WILLIAMSON COUNTY, TEXAS

CHANGE ORDER NUMBER: 11

Project: 221FB39

Roadway: CR 111 Westinghouse

REFERENCE: DW #1 Culvert in Conflict with Existing Waterline

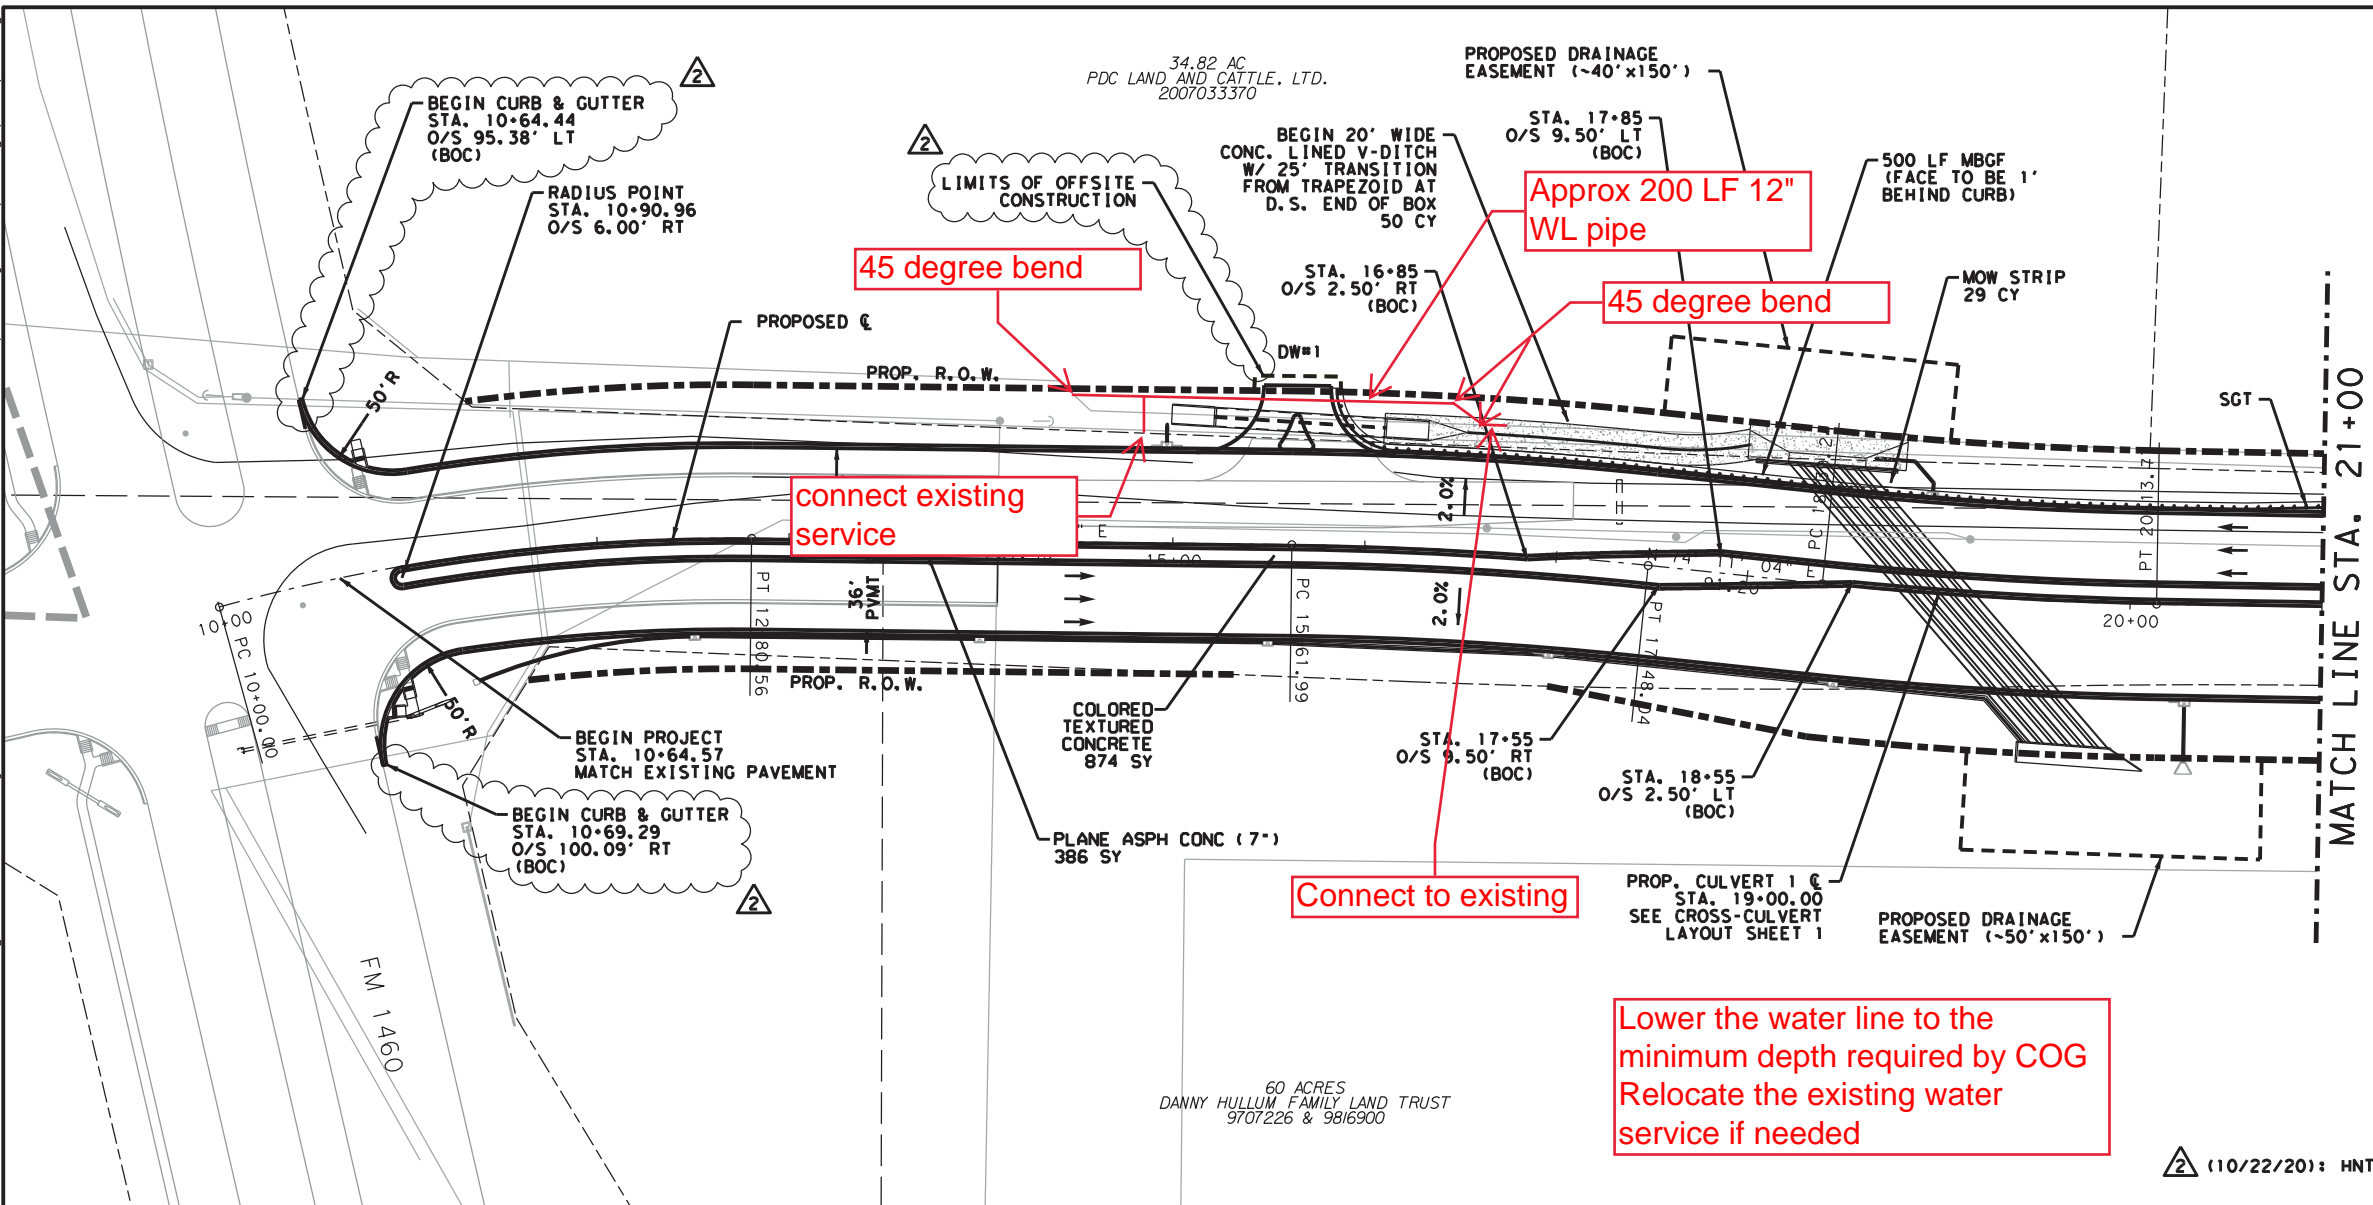
The proposed culvert under DW #1 is shown to be placed directly over the top of the existing waterline.

Downstream:

FL of culvert 827.21

Top of water 826.59

Upstream:

FL of culvert 829.51

Top of water 827.39

There is also an exiting fire hydrant in the riprap on the upstream side of Culvert 1 that may be in conflict with the current proposed slope of the riprap.

Based off of the information provided, please install a new section of 12in WL north of the existing line and 45 degree it back into the existing line on the east side of the proposed box culverts. The depth of the new line should be per COGT Specs. This would also include tying in the existing service line on the west side of the proposed boxes. Please document all field changes for this new line in the As Built plans.

WILLIAMSON COUNTY CR 111 IMPROVEMENTS			
CR 111 PLAN & PROFILE			
SHEET 1 OF 18			
DATE: 1/8/2021	DN:	DW:	CK: AP:
FED. RD. DIV. NO. 6	FEDERAL AID PROJECT NO. ----		SHEET NO. 88
STATE TEXAS	DIST. ---	COUNTY WILLIAMSON	
CONT. ---	SECT. ---	JOB ---	HIGHWAY NO. CR 111

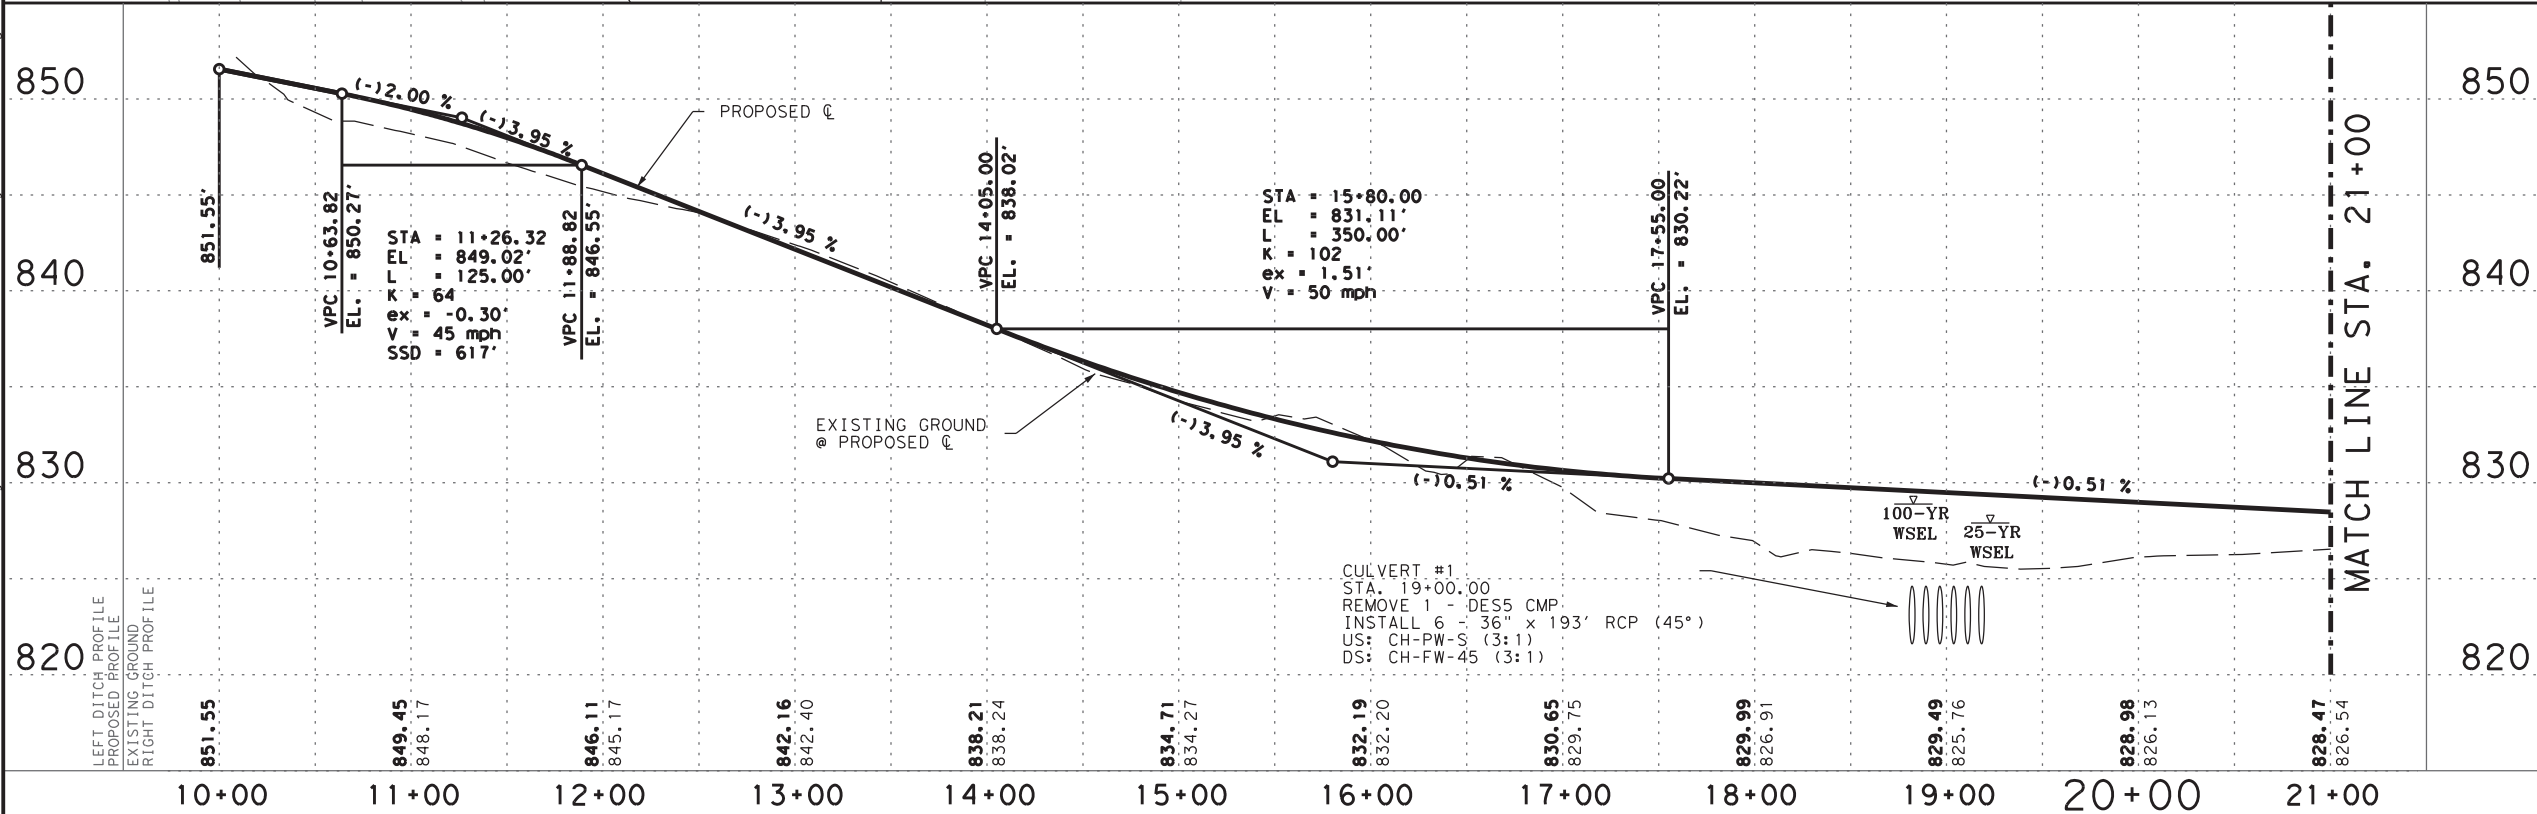
6 Untimely ROW/Utilities 6C: Utilities Not Clear: This Change Order compensates the contractor for relocating the existing 12-inch City of Georgetown water line that is in conflict with the culvert a Driveway 1. The water line is being relocated between the proposed box culvert and the ROW along the north side of the project.

This Change Order provides payment to the Contractor for additional work to relocate the City of Georgetown's 12-inch water line that was in conflict with the proposed drainage culverts at Driveway 1. The cover over the existing water line is insufficient and it is being relocated between the proposed box culvert and the ROW, along the north side of the project. With this relocation there is also a service to the adjacent property that has to be relocated.
